# Certificate of Appropriateness

### **1320 W. Burnham St., Mitchell Street Historic District**

## Date issued 5/9/23

East façade

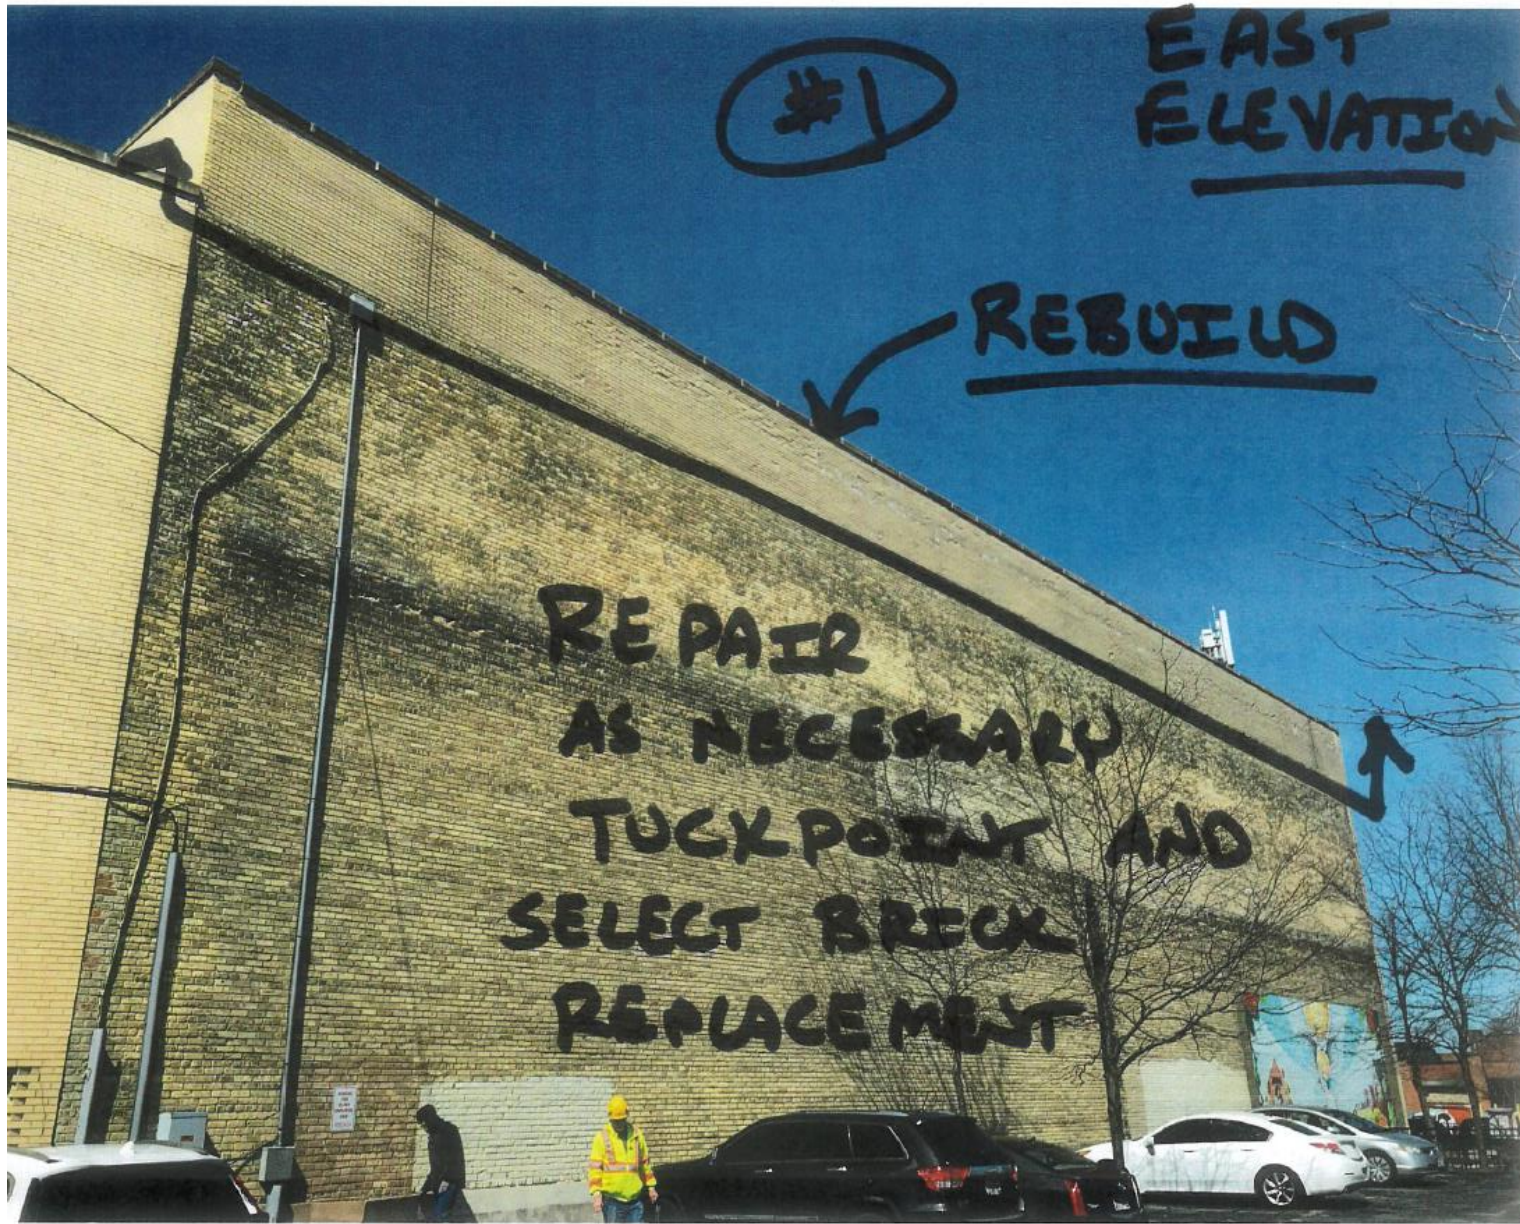
Highlighted areas to be reconstructed in-kind

Penthouse

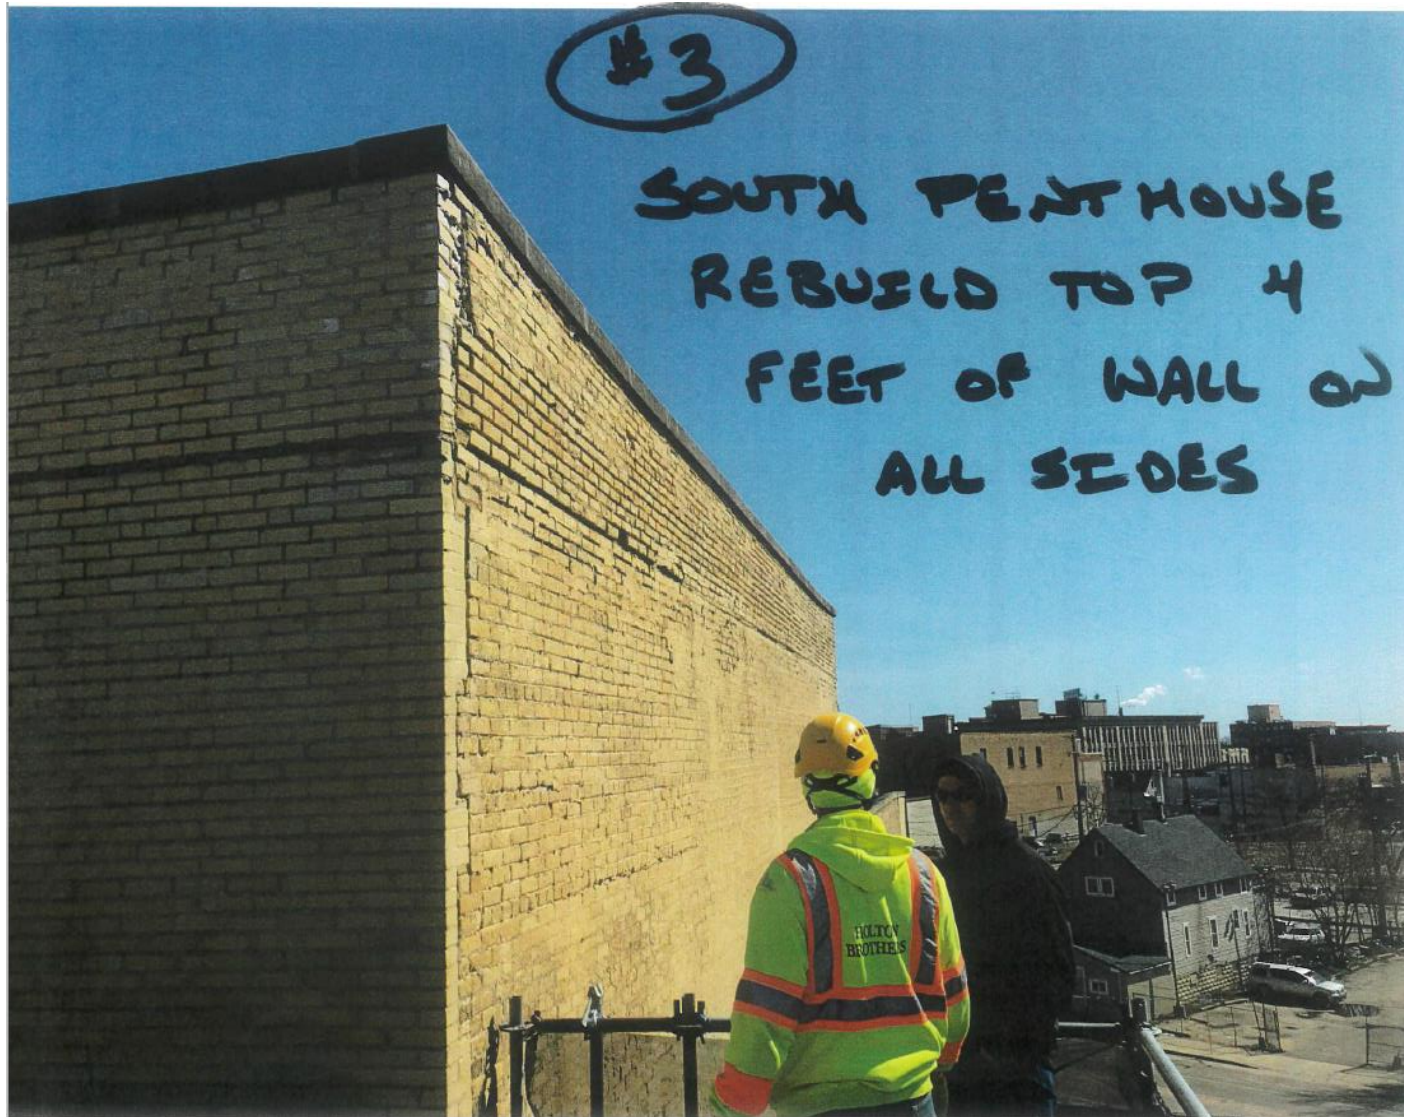
Upper portion of rooftop penthouse to be reconstructed
